FIELD INSPECTION REPORT

1. PROJECT NO 8031 2. DATE 7/21/77 PAGE 1 OF 3

4. ITEM INSPECTED Re-inspection of welds in question in Quality Control inspection
Plan C-63-11-1-3
INT 7-21-77

5. LOCATION Reactor Containment Unit #2 Elev. 253'

90° Location

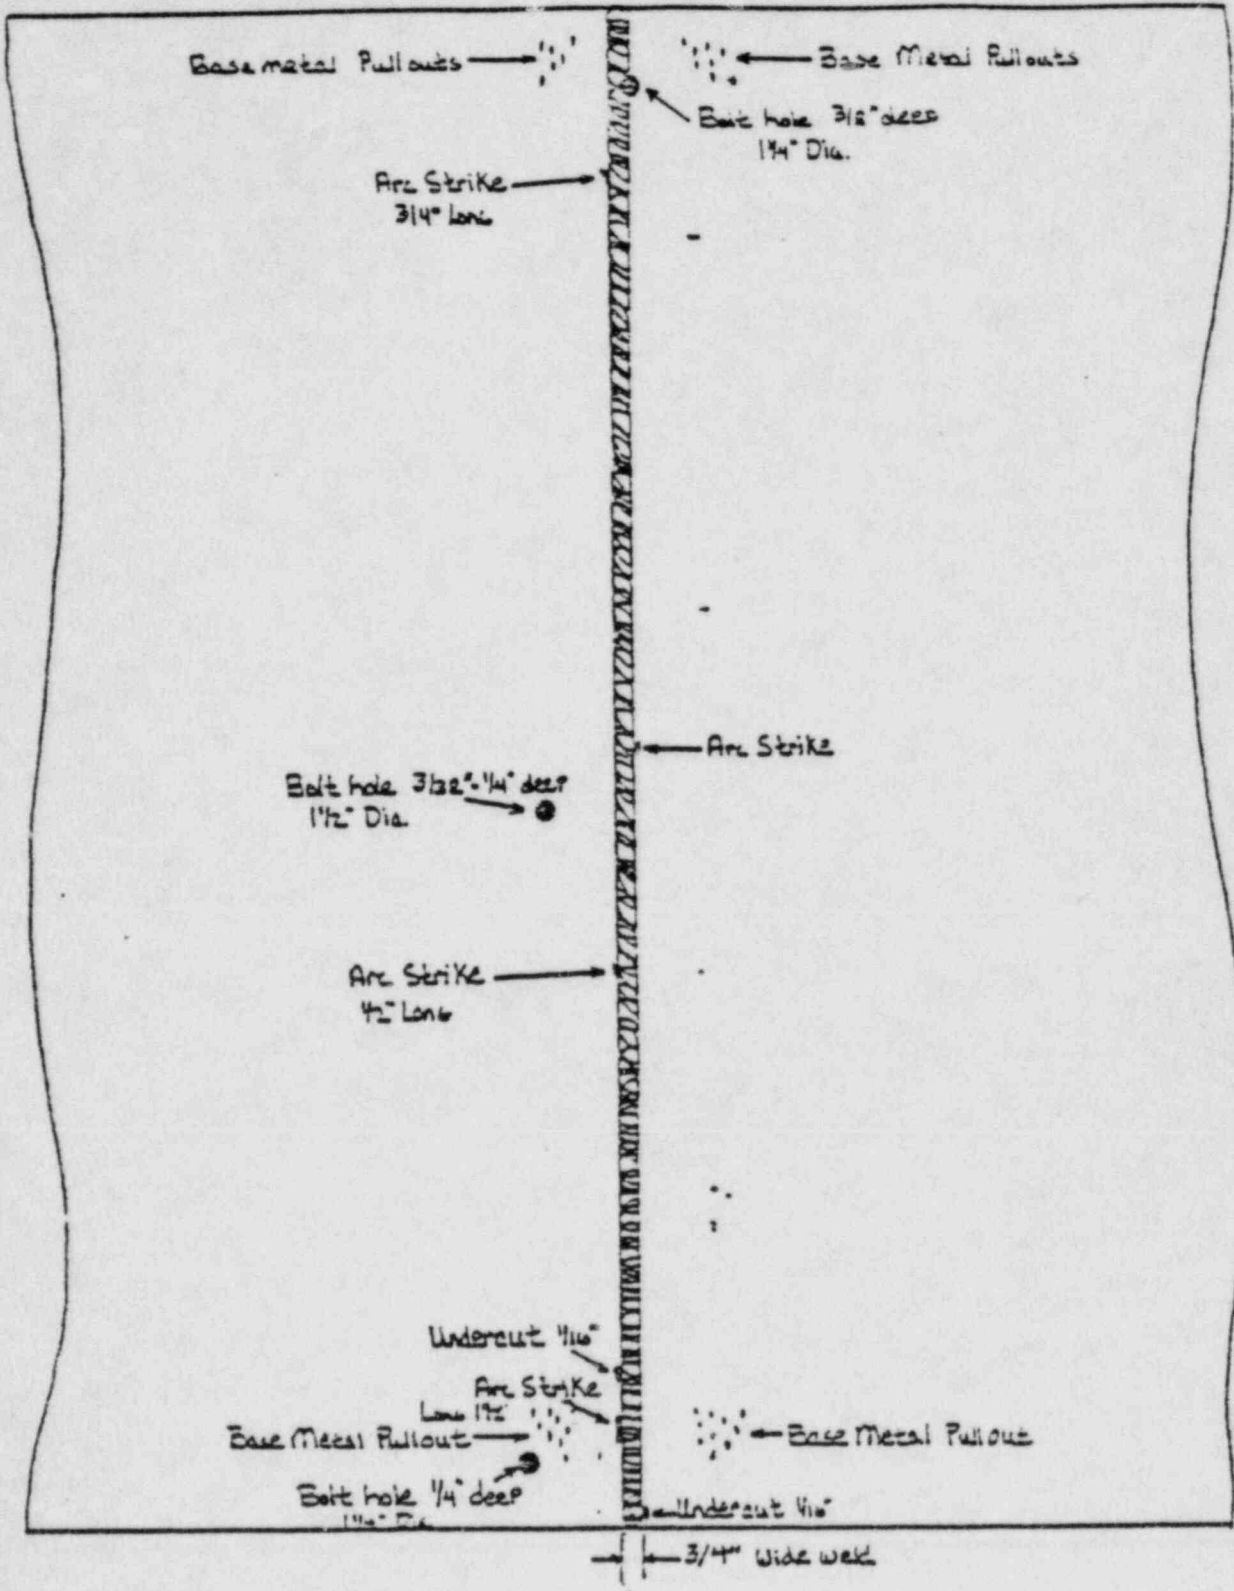
Undercut, Washout at top of weld
